ADDENDUM #1

Reference: Lind Lecture Hall Seating Remodel
Weber State University – Ogden, Utah
Project No.09062810

addendum #1

project name: WSU - Lind Lecture Hall Seating Remodel
project designation: 0924

typ. elevation @ desk

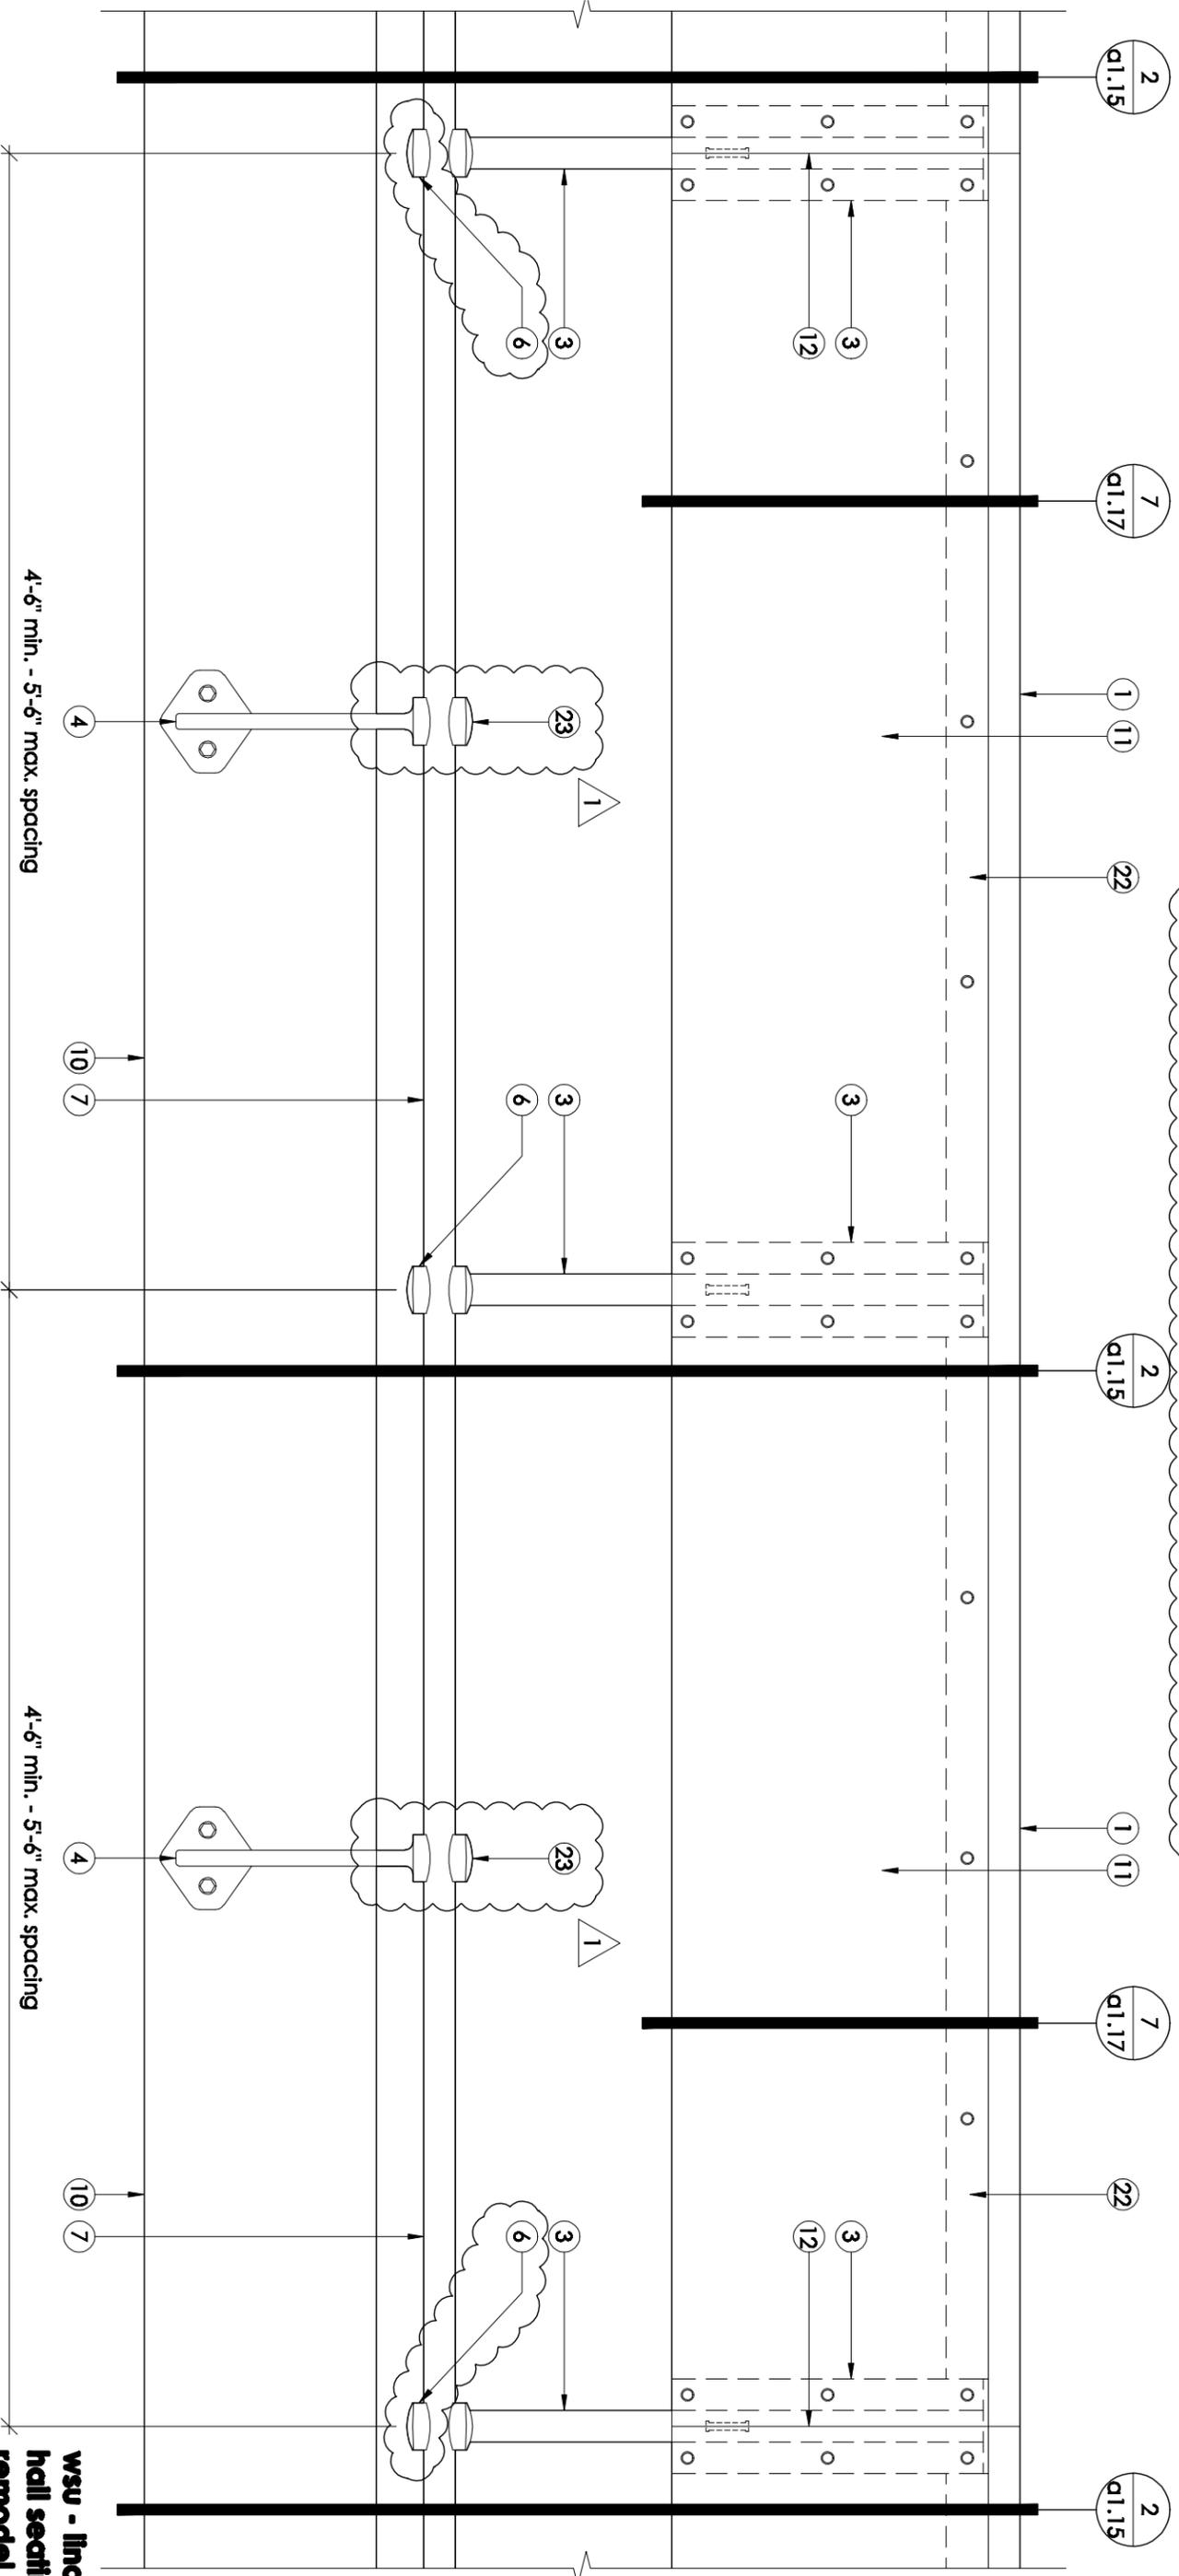
Item VI-2. detail a/a1.15: Modify keyed note "6" and add keyed note "23" to clarify the existing cast bottom brackets to be reused (re: attached drawing add1.1). The existing threaded cast metal bottom brackets removed from the bottom of the existing tablet arm desk brackets shall be reused at the new cast metal desk brackets. There will be surplus threaded bottom brackets that will not need to be reused. The existing non-threaded cast metal bottom brackets removed from the bottom of the existing chairs shall be reused as required at the existing riser brackets where an existing chair or tablet arm desk bracket was previously located. There will be surplus non-threaded bottom brackets that will not need to be reused. All of the existing bottom brackets that are reused shall be prepared and powdercoated as per the specifications.

- 6 Existing threaded cast metal bottom bracket salvaged from bottom of tablet arm desk bracket during demolition.
- 23 Existing non-threaded cast metal bottom bracket salvaged from bottom of chair bracket during demolition.
